# Inspection Photos

Operator: CAERUS PICEANCE LLC - 10456

Location #423081

COGCC

**Photo 2:** See comments under photo 1.

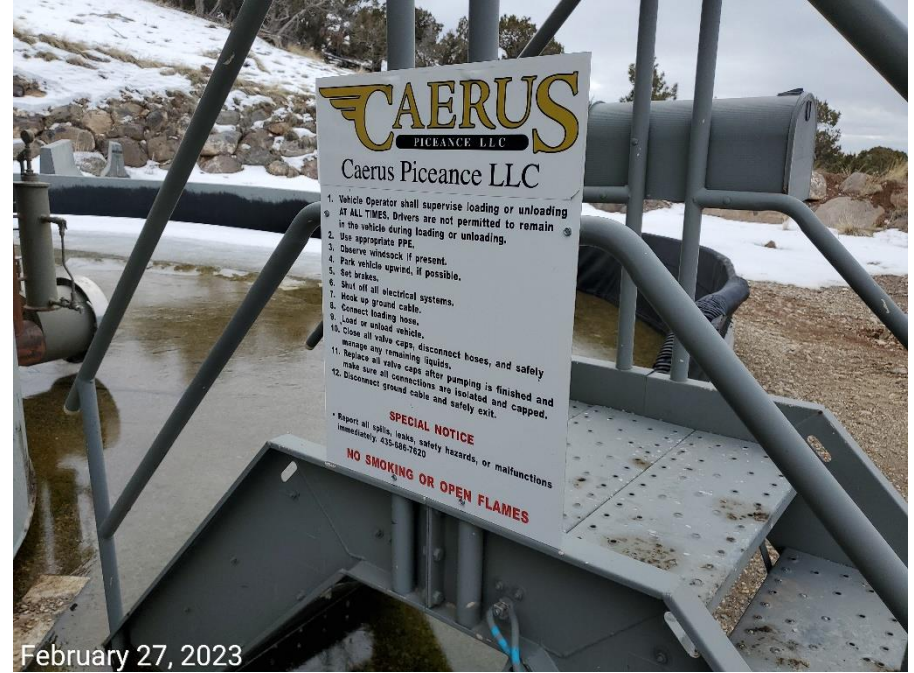
**Photo 1:** Photos 1-2 taken from the west end of the Location. Photos provide an overview of the Location from north, northeast, southeast to south.
